Errata for Dissertation “Dynamic Analysis Tool Development for Advanced Geometry Wind Turbine Blades”

Scott Larwood

last updated: 18 June 2009

Figure 1: Actual Figure 2.17: L-beam with $\theta = 90^\circ$ Verification Results

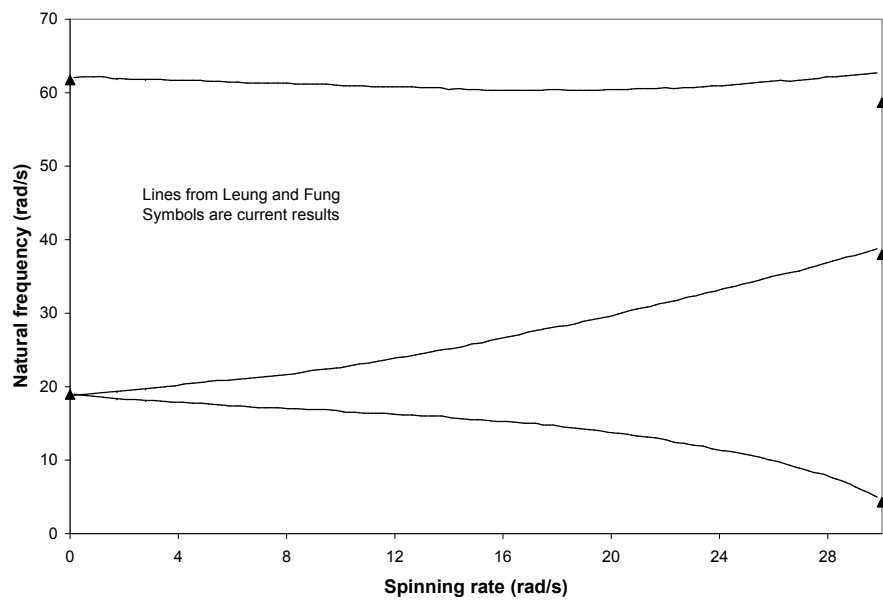
p.43 Fig. 2.17 is incorrect. The correct figure (Fig. 1) is below this complete listing.

Figure 2: Blade tip twist verification (Fig. 3-5)

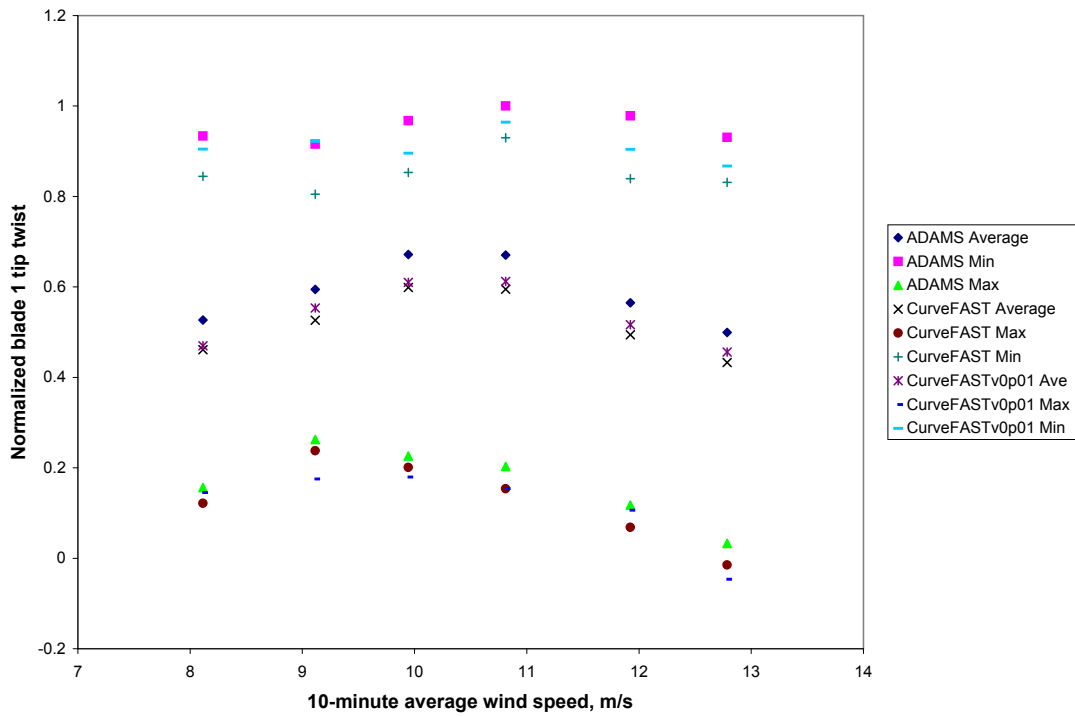
Also, the transformation to the aerodynamics coordinate system should include the live twist, as in:

The author corrected this error in CurveFAST. Figures 2 through 6 show verification results for a revised CurveFAST (version 0.01). These figures would replace Figs. 3-5 to 3-9 in the dissertation.
